WAKE COUNTY DEPARTMENT OF ENVIRONMENTAL SERVICES WELL AND SEWAGE SITE LOCATION PERMIT
NO PERMIT(S) FOR CONSTRUCTION, LOCATION OR RELOCATION ACTIVITY SHALL BE ISSUED
UNTIL AN AUTHORIZATION FOR WASTEWATER SYSTEM CONSTRUCTION HAS BEEN ISSUED

CA Site Plan Part A
PIN# 799.01480845

Attached is a proposed design for a Pressure Manifold Septic System for a single family residence located at 13201 Norwood Road, Wake County, NC

13201 NORWOOD ROAD
Project No. 9977.S1
PRESSURE MANIFOLD SYSTEM
FOR WASTEWATER TREATMENT

PROJECT NO. 151	SCALE 1" = 50'	SHEET TITLE SEPTIC SYSTEM LAYOUT
PROJECT MGR. SM	FIELD WORK SM	PROJECT NAME CAROLINA RESTORATION 13201 NORWOOD ROAD WAKE COUNTY, NORTH CAROLINA
OWN BY

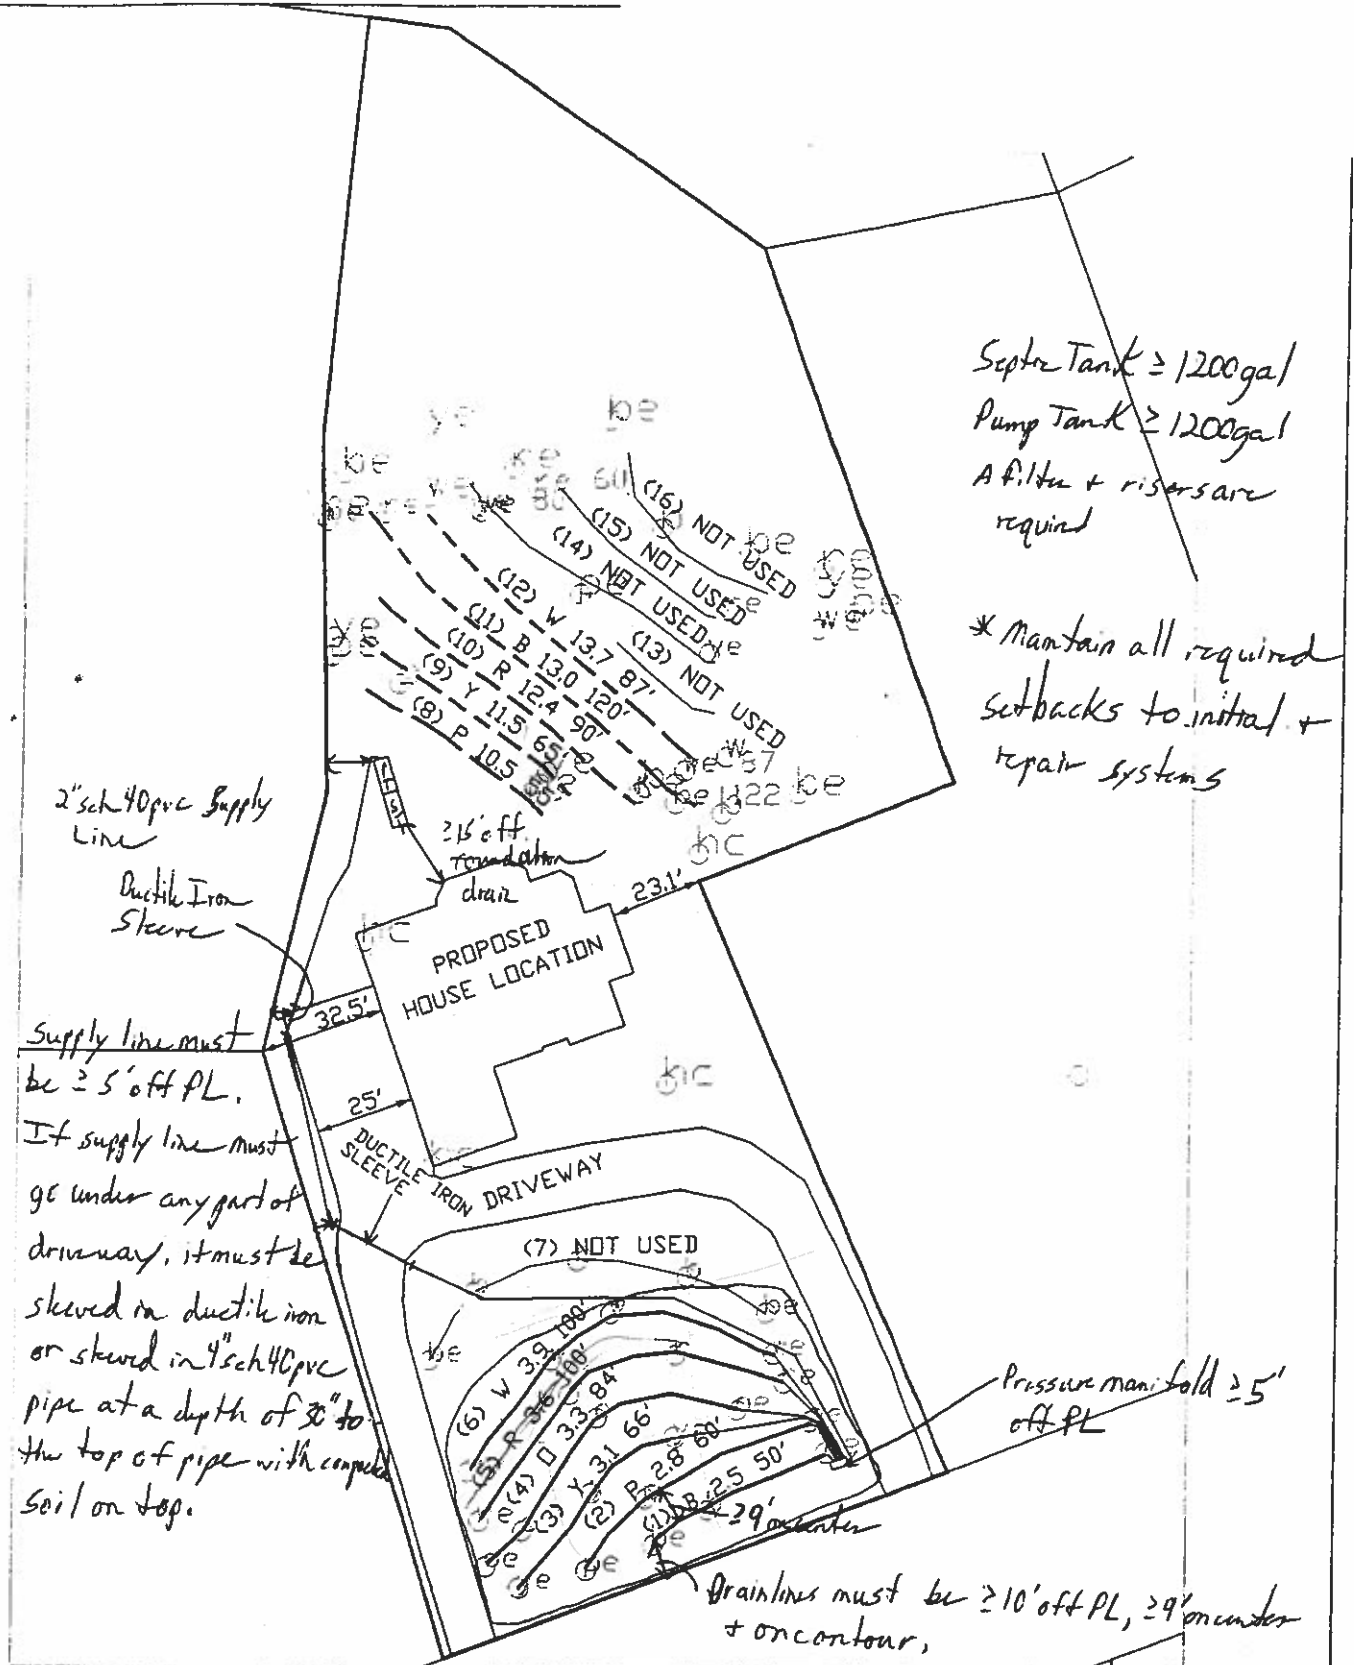
100% Dose Volume 296.10
 Percent Dose Volume ~~70%~~ 77
 Total ~~207.27~~ 228
 Pump Run Time ~~4.57~~ 5.02

PROJECT NO. 9077.S1	SCALE 1" = 50'	SHEET TITLE: REPAIR SEPTIC SYSTEM LAYOUT
PROJECT MGR. MB	FIELD WORK SM	PROJECT NAME: CAROLINA RESTORATION 13201 NORWOOD ROAD WAKE COUNTY, NORTH CAROLINA JANUARY 2008
DRAWN BY SM		
\\SEC\SECFILES\6185\LOT 42.DWG

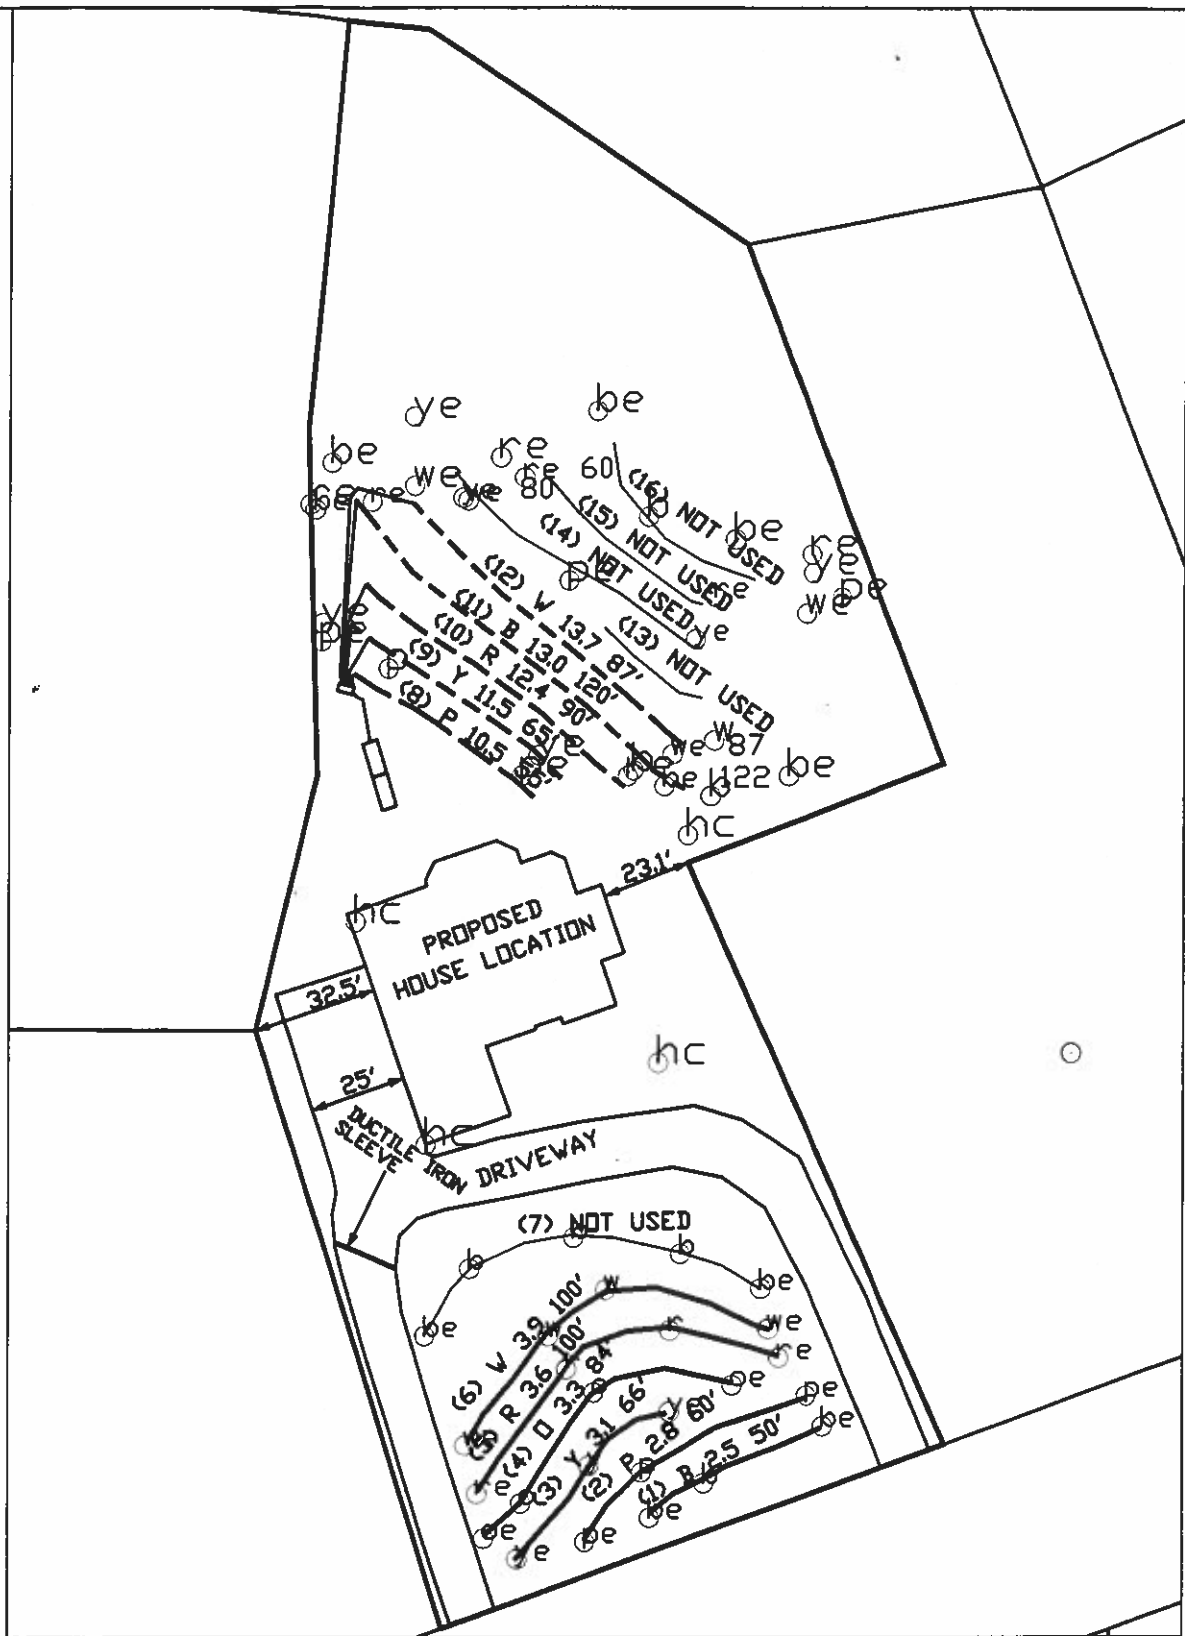
100% Dose Volume **271.37 ✓**
Percent Dose Volume **85% ✓**
Total **230.66 ✓**
